ADDENDUM NO. 1
CLASSROOM ADDITION TO ELVIN HILL ELEMENTARY SCHOOL
Architect Job No. 25-34
December 2, 2025
DCM #2025854

The Plans and Specifications are hereby amended. The following supersedes all contrary and/or conflicting information and is made part of the contract documents.

SHEET TITLE:
PLANS AND DETAILS -
BERM REMOVAL & NEW
BRICK FACADE

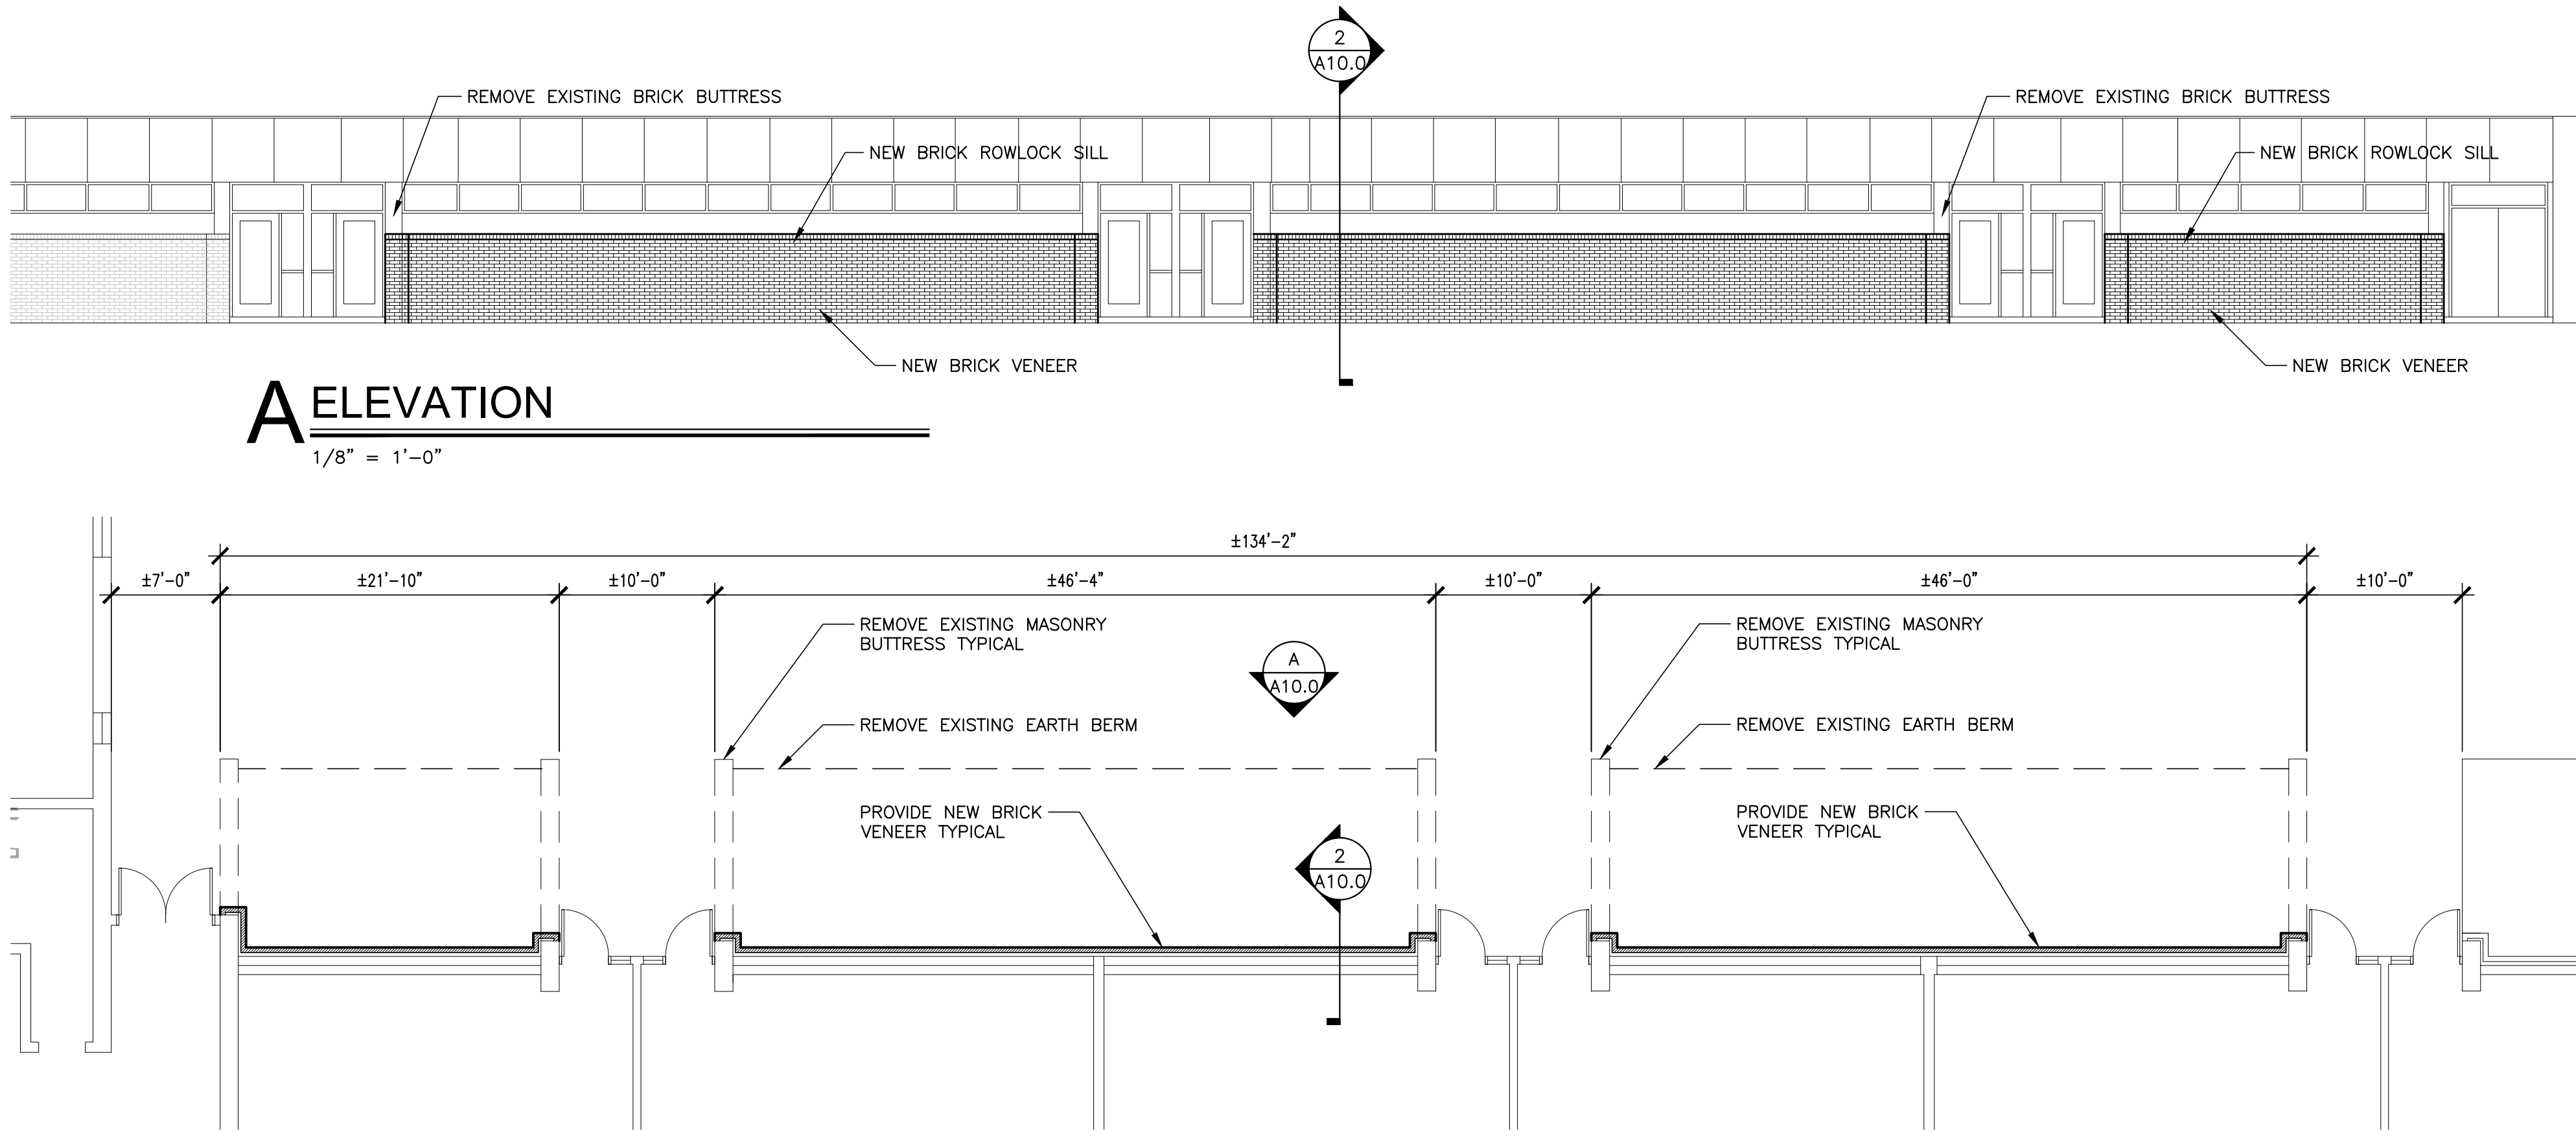
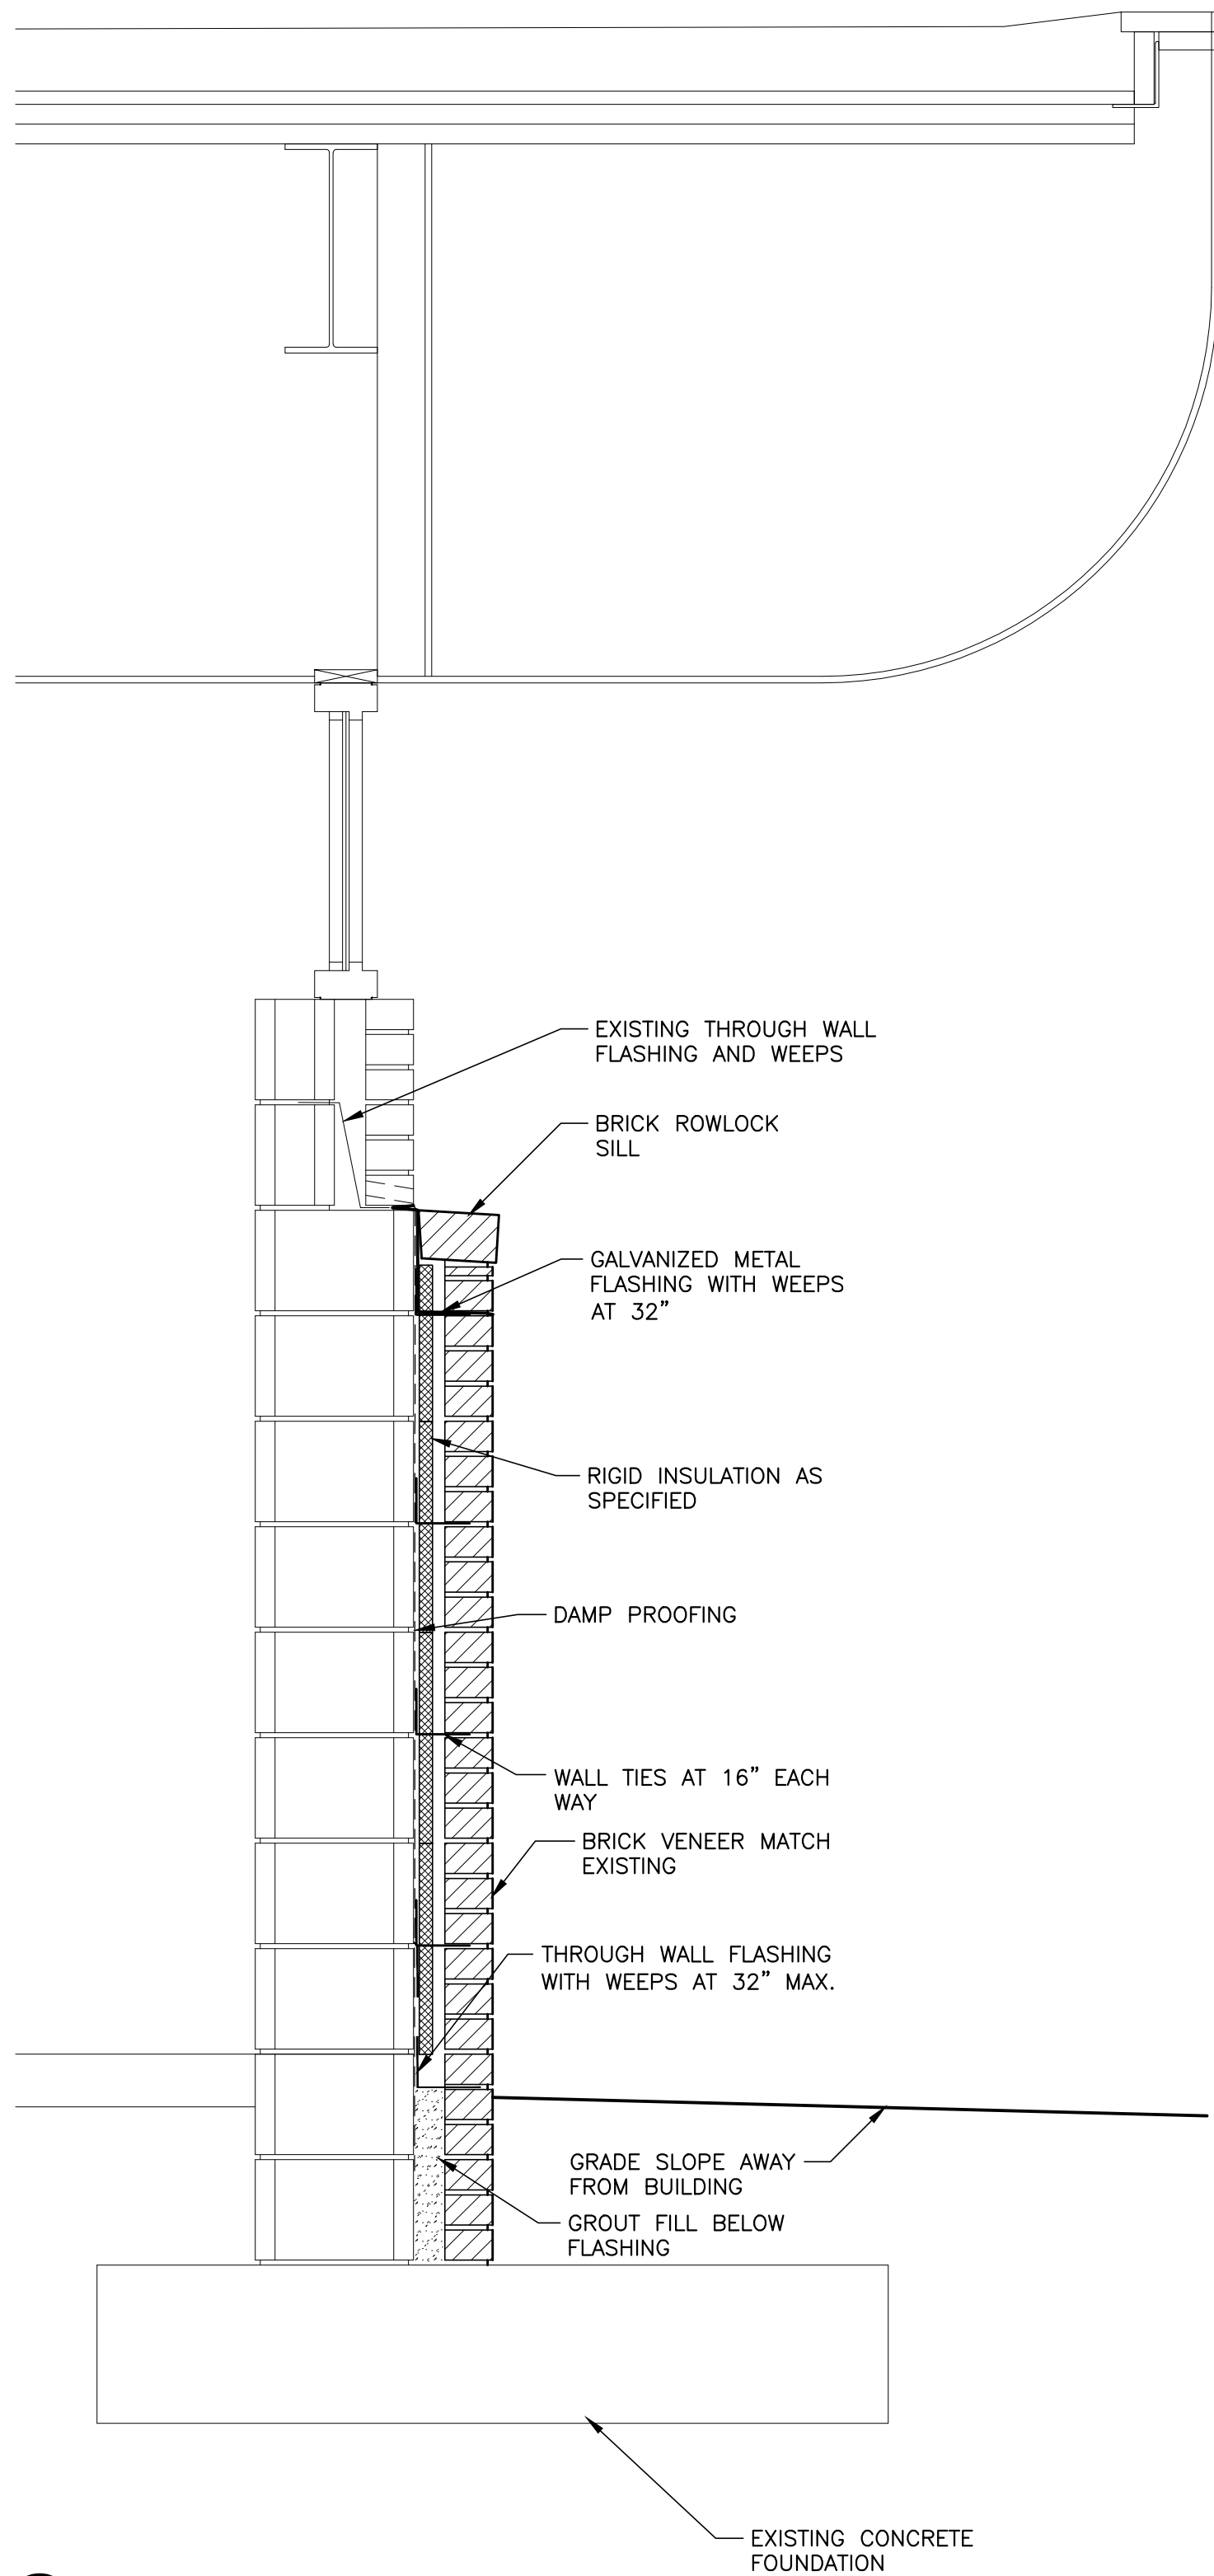
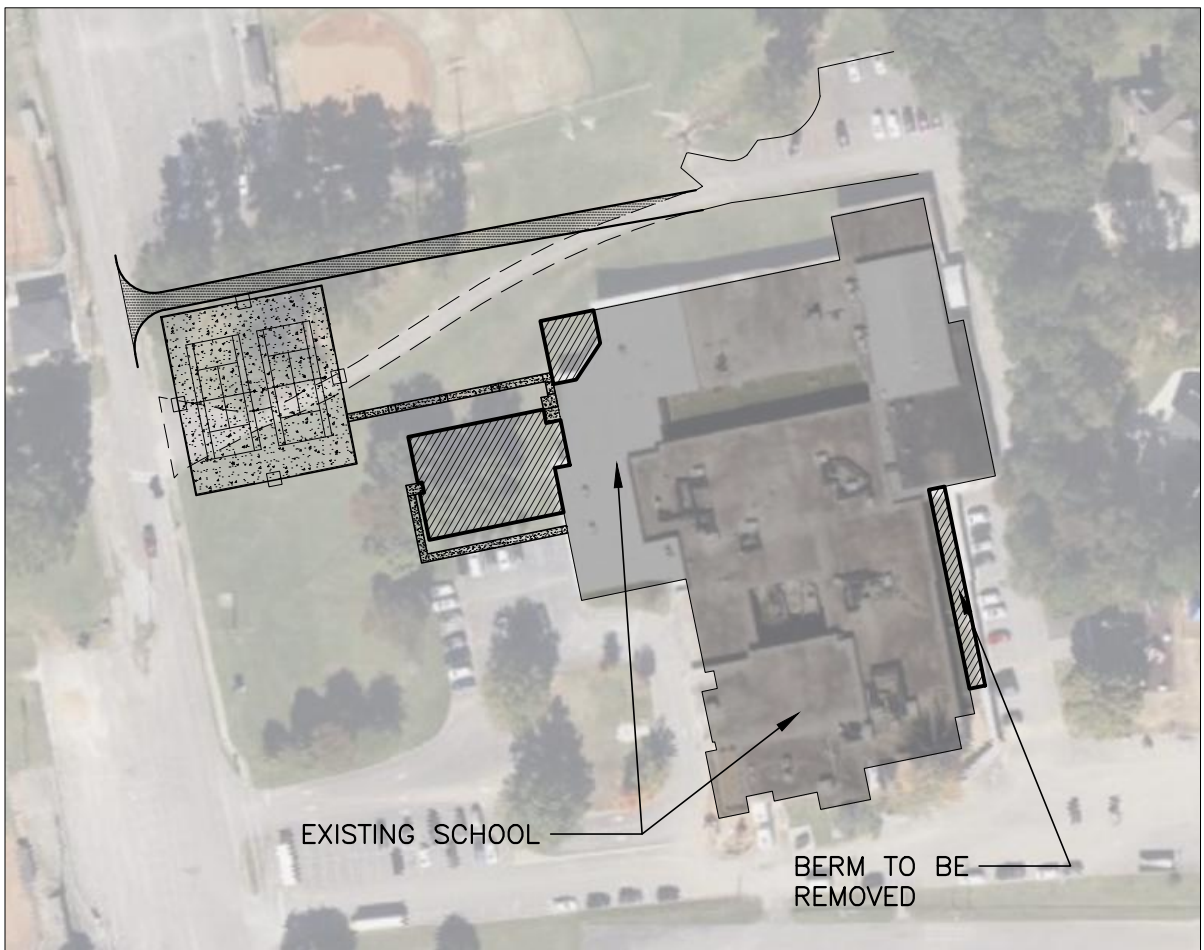
1. **Sheet A2.0.1** – Floor Plan Additional Alternate: See clouded for revisions.
2. **Sheet A10.0** – Plans and Details – Berm Removal & New Brick Facade: See clouded for revisions.
3. **Sheet M0.2** – Mechanical Schedules: See clouded for revisions.
4. **Sheet M0.5** – Mechanical Calculations and Controls: See clouded for revisions.
5. **Sheet M0.6** – Mechanical Controls: See clouded for revisions.
